REMARKS

By way of background, the specification at page 1 states that the present invention relates to a design for an access cell and a method for enabling automatic insertion of access cells into an integrated circuit design. As is known to those skilled in the art, an access cell does not perform any of the logical

FIG. 1

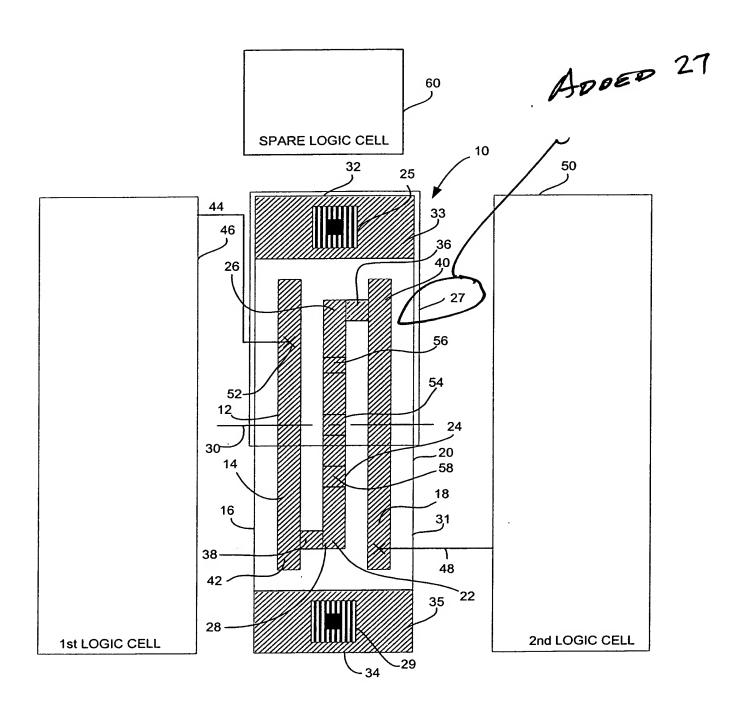
While the examiner has not objected to the drawings, in the prior prosecution, it was noted that in Fig. 4 reference characters 70 and 72 were both indicated to designate the computer and in Fig. 1 the reference number 27 was missing. Applicants have enclosed an annotated corrected copy of Figs. 1 and 4,

as well as a clean copy of these figures and request that these drawings be accepted.
